Overall Japan image of Flex-PLI Introduction into gtr as well as ECE

Comparison Table of gtr 9 Amendments 01 (GRSP-2010-37) and ECE 01 Series Amendments (GRSP-48-09) <Updated Japan Proposals>

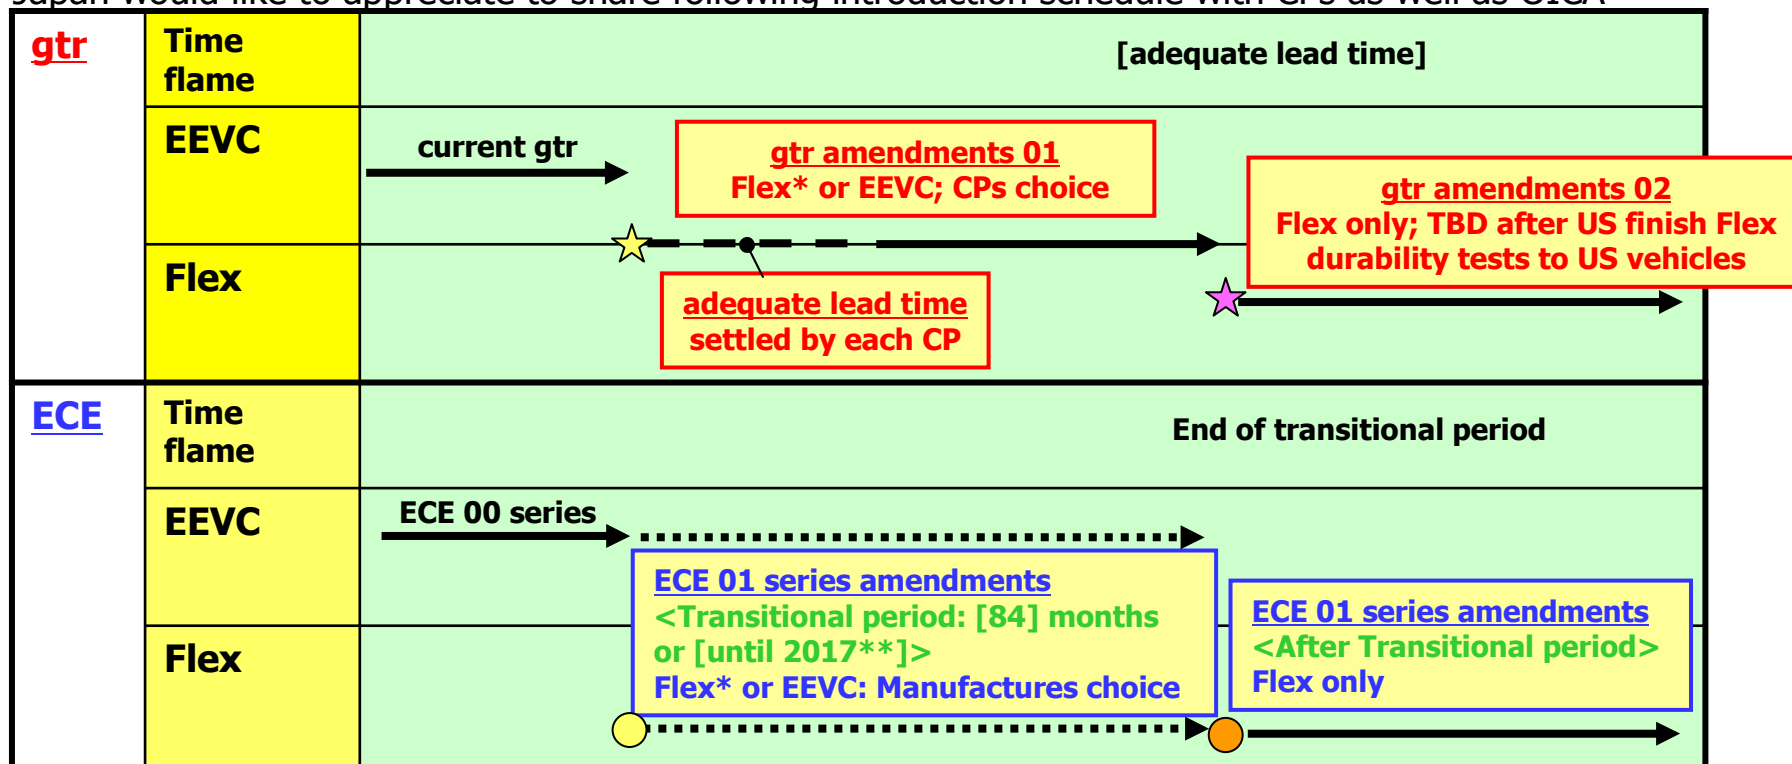
- Japan would like to appreciate to share following introduction schedule with CPs as well as OICA

* EEVC Shearing Displacement requirement is possible to use alternatively of Flex ACL/PCL requirement

** One of an idea to set transitional period using a year

..... Transitional period; **[84] months** after the Date of Entry into Force of ECE 01 series amendments
